# E C O L O G I C A L R E V I E W

## **South Lake De Cade Freshwater Introduction - Construction Unit 1**

State No. TE-39

**95% ECOLOGICAL REVIEW**  
**South Lake De Cade Freshwater Introduction - Construction Unit 1**

Figure 3. Preliminary Lake Rim Revetment (USDA-NRCS 2004b).

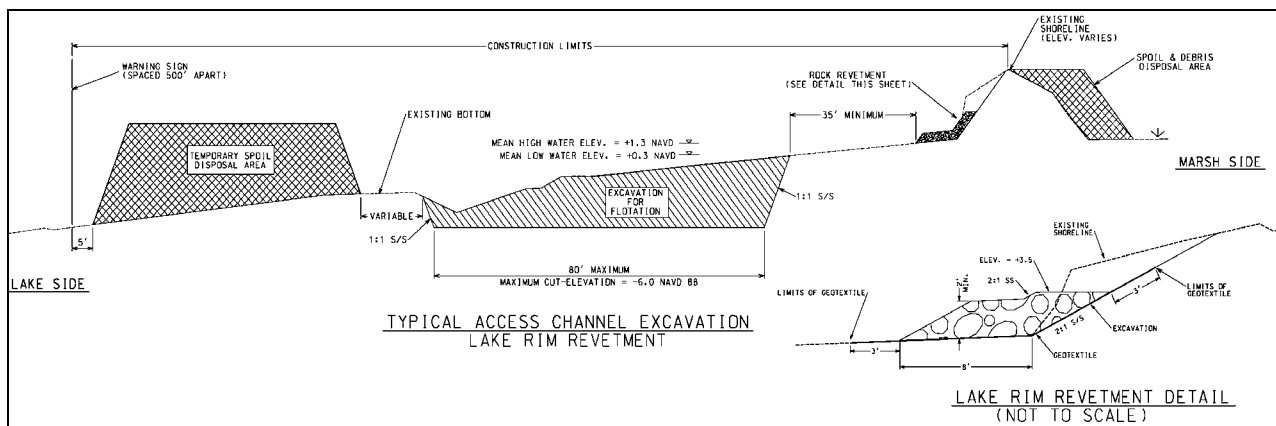
Due to the settlement projections and high wave energies which develop in Lake De Cade, engineers with LDNR and the Natural Resources Conservation Service (NRCS) agreed to modify the shoreline protection structure from a foreshore rock dike to a rock revetment (Figure 3). Soil conditions along the Lake De Cade shoreline are expected to be better than the foreshore soil borings analyzed in the two prior geotechnical investigations because periodic re-building of the lake shoreline, previously undertaken by landowners, has pre-consolidated the underlying soil layers. The rock revetment will be built to an elevation of +3.5 feet NAVD 88 and at a side slope of 2(H):1(V). Geotextile material will be used as a separator and reinforcement for the rock riprap material and the native soils. NRCS engineers determined that a design wave height of 1.05 feet would not overtop the shoreline revetment height of +3.5 feet NAVD 88 (USDA-NRCS 2004a). It was also assumed, based on the soil conditions and the revised design, that the side slope would be adequate and that the structure would settle approximately 0.5 feet (Ronnie Faulkner, NRCS, Personal Communications, June 15, 2004). A maintenance lift was approved at target years 7 and 14 post-construction (TY7 and TY14) to recap the rock structure and maintain the target elevation. Spoil excavated from the access channel will be permanently placed on the south-facing slope of the existing embankment (Figure 3).

Stability and settlement analyses of the armor shoreline protection were conducted by Soil Testing Engineers, Inc. and Burns Cooley Dennis, Inc. However, the reported settlement estimates, although satisfactorily addressed in the geotechnical analyses, do not factor in relative sea level rise (subsidence + eustasy), which according to *Coast 2050* and Penland and Ramsey (1990) ranges between 0.25–0.43 inches per year or 5.0–8.6 inches over twenty years. Both settlement and subsidence estimates should be considered before finalizing project features and in the development of operations, maintenance, and rehabilitation plans.

Since the 95% Design Review meeting, two project features, a weir and an earthen embankment, were dropped from the current project design. However, based on information gathered from similar restoration projects, engineering designs and computations, and related literature, the current proposed shoreline protection structure will likely achieve the desired ecological goals. At this time, the level of design of the project’s physical effects and confidence in goal attainability warrant continued progress toward construction authorization.
